**Addendum No. 3, IFB 20-58**

To: Prospective Bidders IFB 20-58, Parking Repairs and Waterproofing – Buena Vista Garage

**Re:** Responses to Questions from Prospective Applicants; Corrections of Mathematical Errors on Two Filed Sub-bids

**S-101**

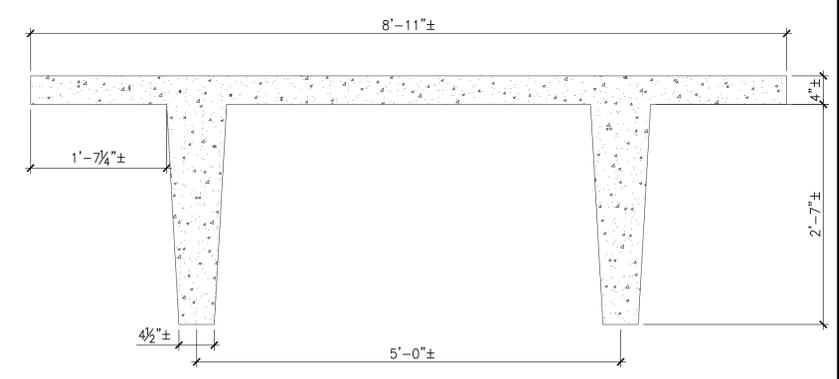
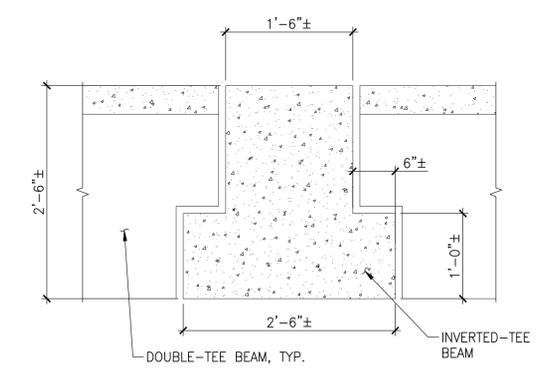
| Item Number | Question   | Answer   |
|-------------|--|--|
| 10          | Does the existing subframing within the garage need to be removed to perform the repairs?  | The existing channels at the subframes need to be removed to perform the required repairs. In addition, the existing welds between the double-tee beam flanges need to be broken to perform the repairs. The existing angles may remain. The channels shall be reinstalled once the repairs are completed. The connections at the double-tee beam flanges will be rewelded once the repairs are completed as well. These associated costs will be included as part of the concrete repair costs. See the attached drawing S-101 with revised note for additional information.  |
